BCA ASSESSMENT REPORT

1102 Barrenjoey Road, Palm Beach NSW 2108

Prepared for: Reform Projects / **Project No.:** 210084

Date: 14th April 2021 / **Status:** Revision 02

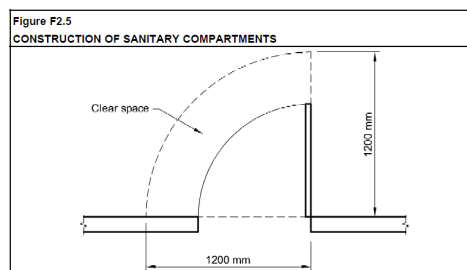
It is noted that although the commercial tenancies show sanitary facility, final numbers are to be assessed once the tenancies are let – in particular where and F&B will consist of more than 20 occupants in each space.

Note: Architectural details, specifications and design certifications are to be prepared by a suitably qualified design practitioner (Registered Architect) and submitted to the satisfaction of the Registered Certifier with the Construction Certificate application.
